Title - Sujet DUMP TRUCK, W/SPREADER & PLOWS	
Solicitation No. - N° de l'invitation W8476-133974/A	Amendment No. - N° modif. 003
Client Reference No. - N° de référence du client W8476-133974	Date 2012-09-27
GETS Reference No. - N° de référence de SEAG PW-\$\$HP-916-61040	
File No. - N° de dossier hp916.W8476-133974	CCC No./N° CCC - FMS No./N° VME
Solicitation Closes - L'invitation prend fin at - à 02:00 PM on - le 2012-10-10	Time Zone Fuseau horaire Eastern Daylight Saving Time EDT
F.O.B. - F.A.B. Plant-Usine: <input type="checkbox"/> Destination: <input checked="" type="checkbox"/> Other-Autre: <input type="checkbox"/>	
Address Enquiries to: - Adresser toutes questions à: Paravan, Tony	Buyer Id - Id de l'acheteur hp916
Telephone No. - N° de téléphone (819) 956-3963 ()	FAX No. - N° de FAX () -
Destination - of Goods, Services, and Construction: Destination - des biens, services et construction:

This Solicitation Amendment 003 is raised to amend the Purchase Description, dated 15 August 2012, and to provide a response to questions from a potential bidder.

ROTOGRIP®

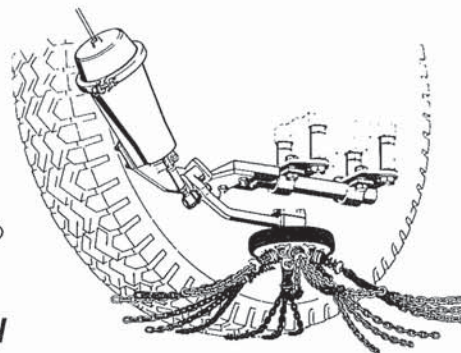
Q 2:

Item 3.7.23 (e) Traction Aid Device

Would "Roto Grip Traction Aid be considered as an equivalent. (See attached)

A 2:

The requirement is a shall(E) and subject to technical authority approved equivalent. The proposed traction aid device is acceptable.
